December 31, 1982
ST-HL-AE-919
File No: G9.15

South Texas Project
Units 1 & 2
Docket Nos. STN 50-498, STN 50-499
Responses to NRC Review Questions

RESPONSES TO NRC QUESTIONS
220.06, 220.08, 220.09,
230.01, 230.04, 231.02 and 231.03

Figure 6

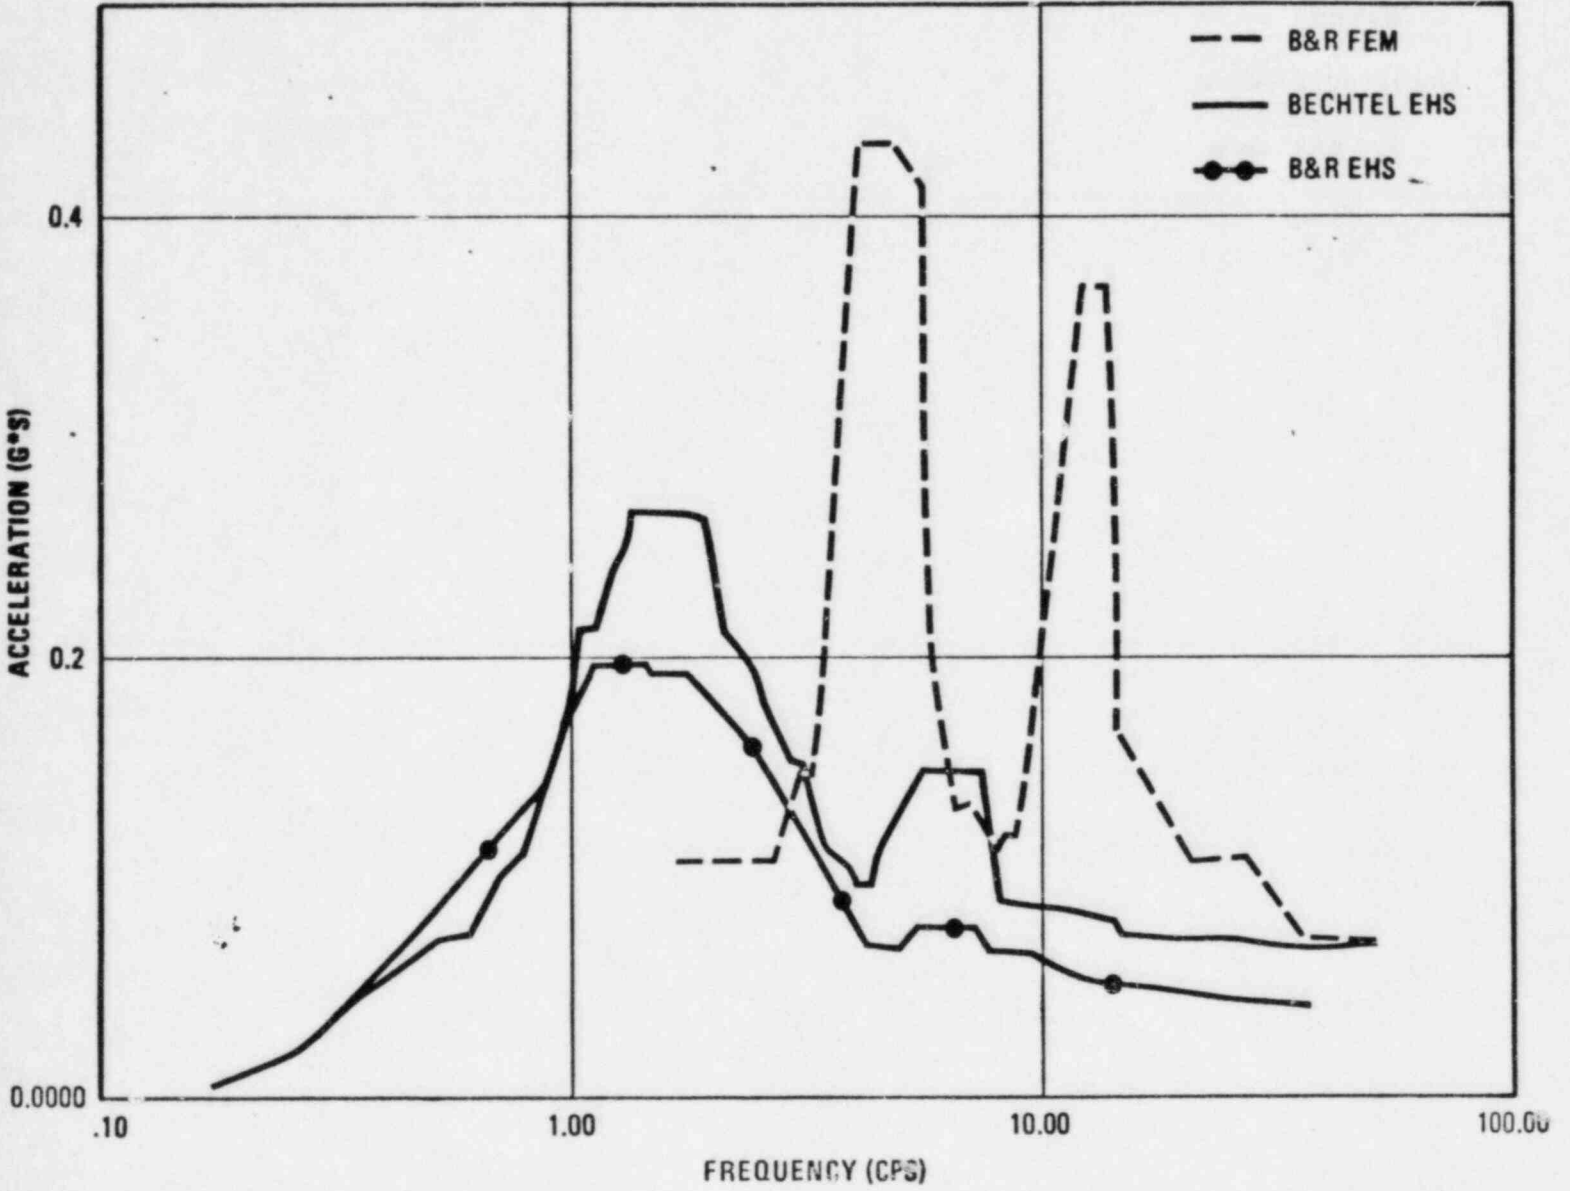
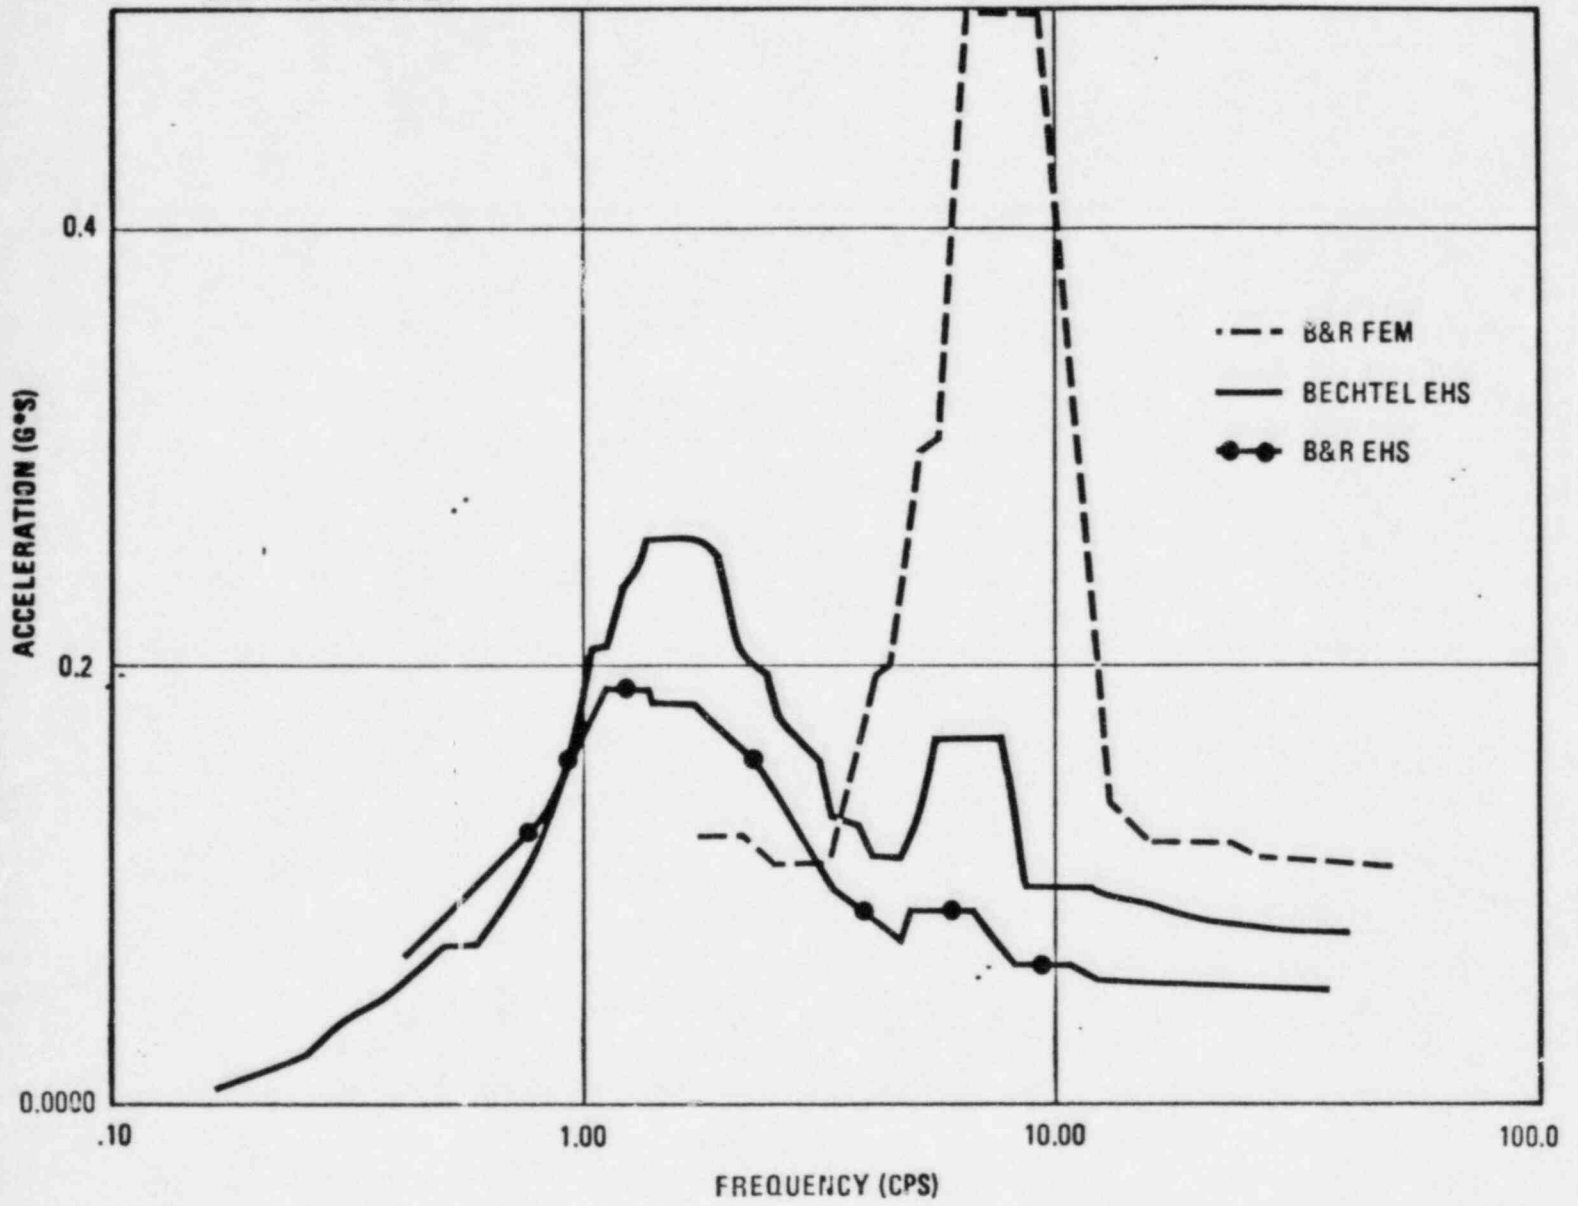
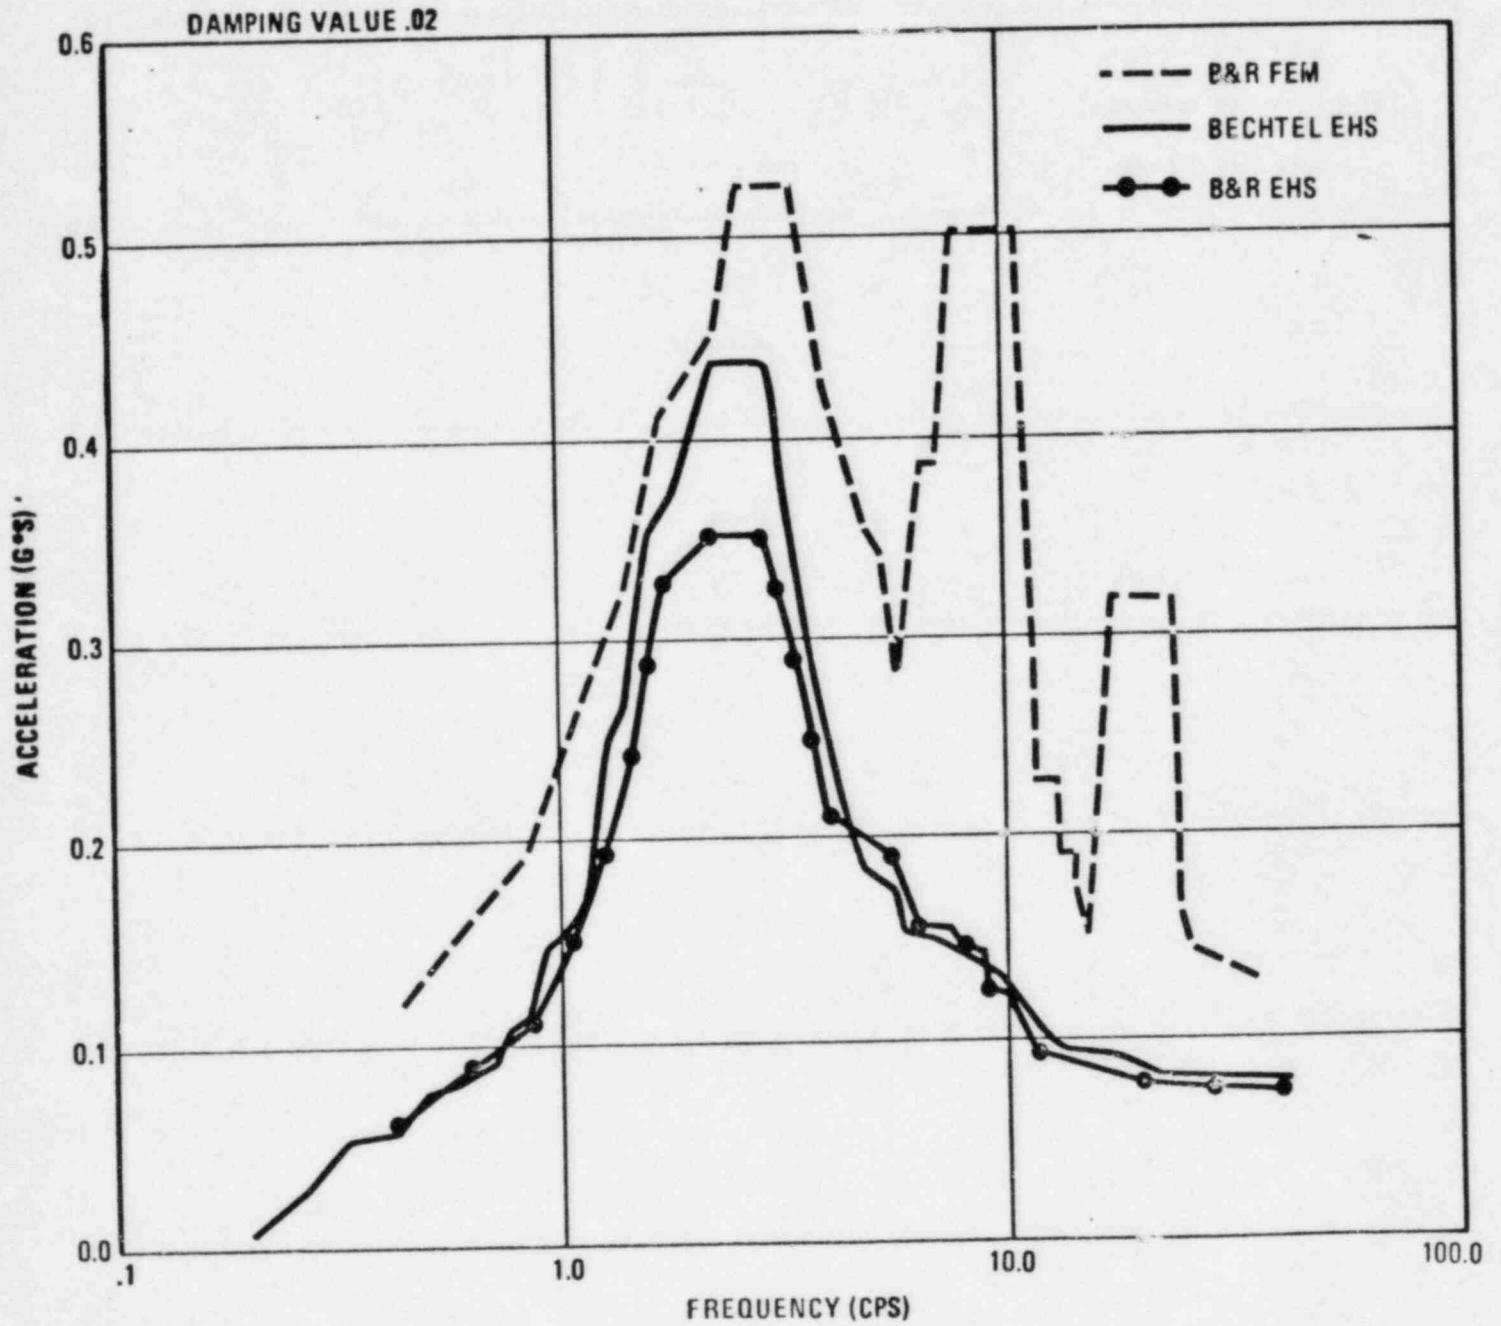
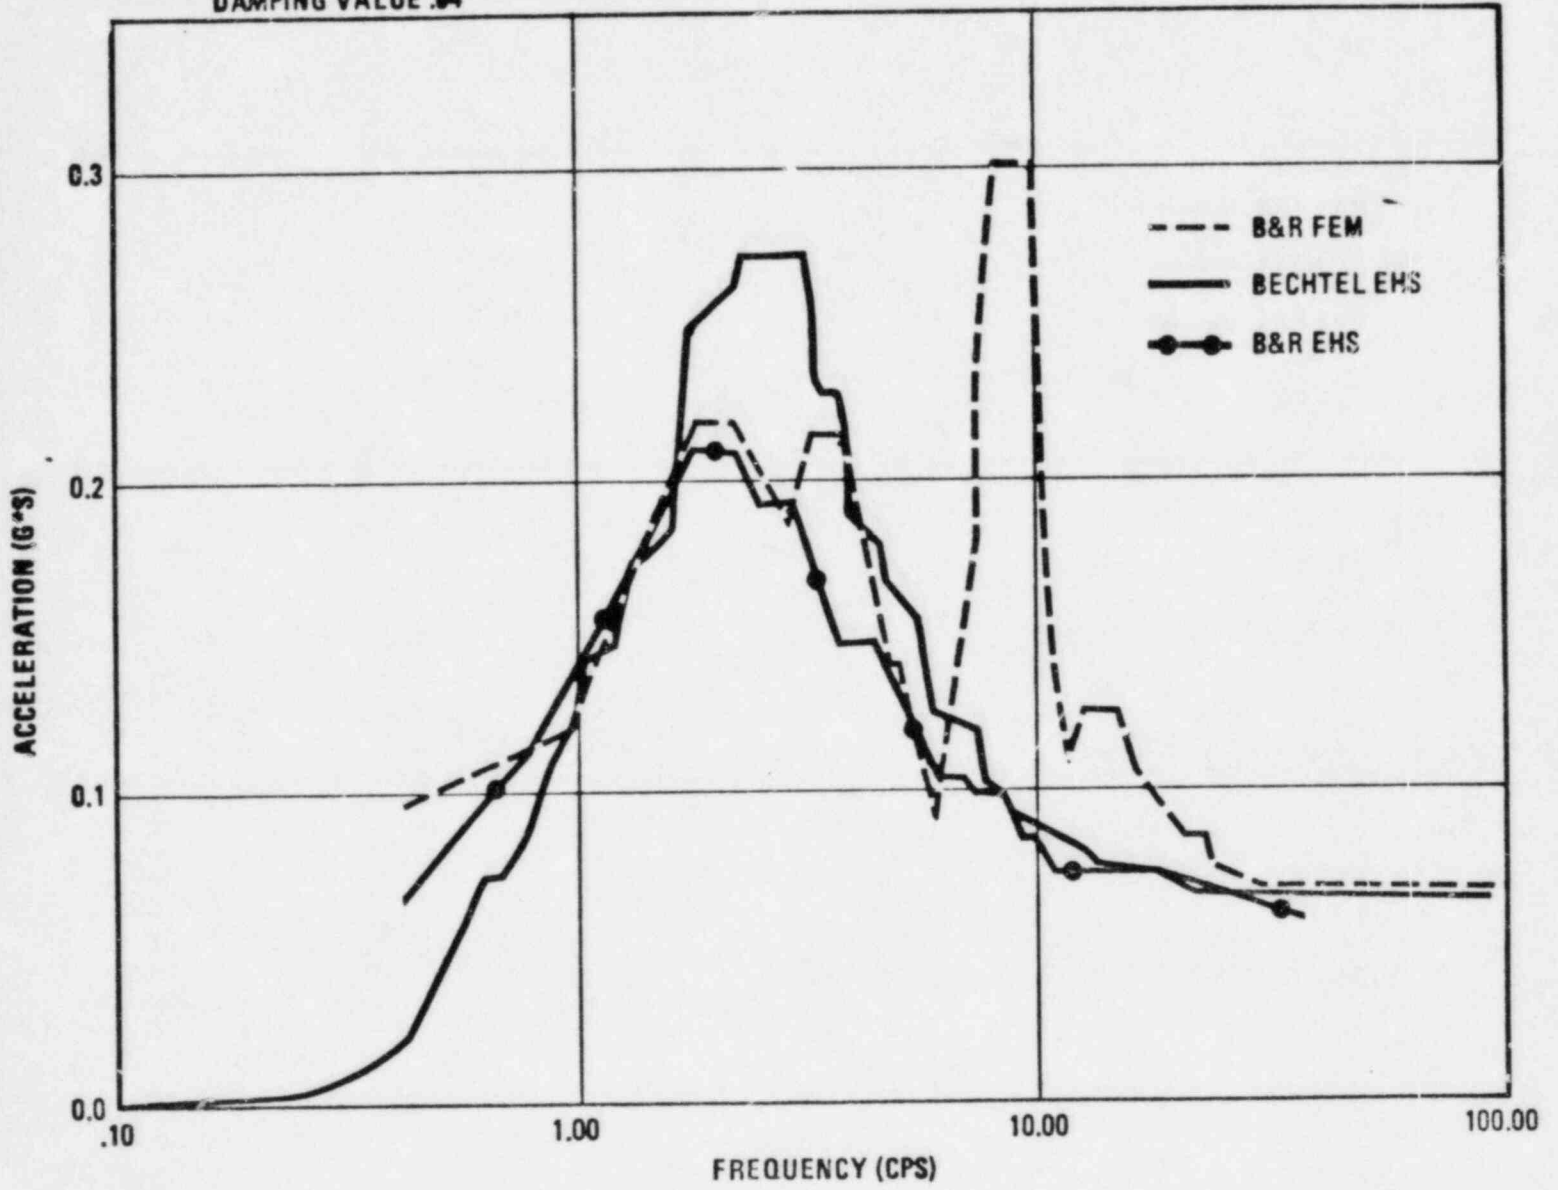
Use Elastic Half Space Method of Analysis without reducing the input motion due to embedment of structure in soil. Apply the R.G. 1.60 motion properly anchored at the OBE/SSE "g" values in the free field at the foundation level, and compare the resulting response spectra with those of Finite Element Method. The applicant should demonstrate that at least the intent of the following position is fully met:

The above mentioned comparison of floor response spectra needs to be done only for key structures at key levels, e.g., 6 key levels of reactor containment building, 4 key levels of auxiliary building, etc.

The FEM spectra envelopes the EHS spectra for the frequency range that is relevant for the design and/or qualification of structural elements, and essentially all equipment and components. The most significant difference is restricted to the low frequency range ($f < 4$ cps, generally), corresponding to soil-structure interaction frequencies where the EHS spectral response for horizontal directions in some buildings is distinctly higher than the FEM spectra. This difference prevails and is significant only in the RCB. In the FHB and the DGB the difference is evident to an insignificant extent, and in the MEAB it is essentially non-existent (see figures 1, 2, 3 and 4). Therefore the difference is well bounded and suitable for systematic assessment by natural-frequency segregation of the limited number of items susceptible to the higher seismic response developed exclusively in the low frequency range.

The comparison of FEM and EHS response spectra has been performed for the RCB, MEAB, FHB and DGB for the OBE event. All levels and locations within buildings corresponding to the original spectra will be compared for OBE and SSE events in order to permit complete implementation of the program described above.

The EHS spectra does not result in higher zero-period accelerations nor in higher peak amplifications than those obtained from the FEM spectra. Therefore the seismic designs of all the superstructures and most of the structural subsystems, which invariably have frequencies higher than 4 cps or are already designed for near peak seismic response, are not affected by the EHS-augmented spectra. Accordingly there is no need to rely on a justification of structures by means of existing design margins nor by means of the actual as-built material strengths as suggested in Question 220.08.
